Access Compliance Report Public Rights-of-Way (Curb Ramps)

Main Street: CHANTILLY_LN		Cross Street: BENJAMIN_DR		Location: S
----------------------------------	--	----------------------------------	--	--------------------

ADA ID: RPRK211020155056	Ramp Type: Type 4 - Parallel	Initial Pass/Fail: Fail	Overall Compliance: No	Severity Score: 2
---------------------------------	-------------------------------------	--------------------------------	-------------------------------	--------------------------

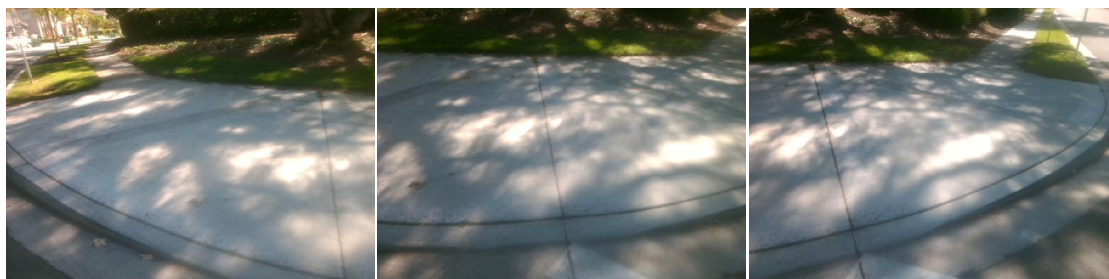
Remove & Replace Curb Ramp With Two New Directional Ramps or Equivalent. Restripe Crosswalk.

R304.2.2, R204.3, R304.5.3, STD 1115
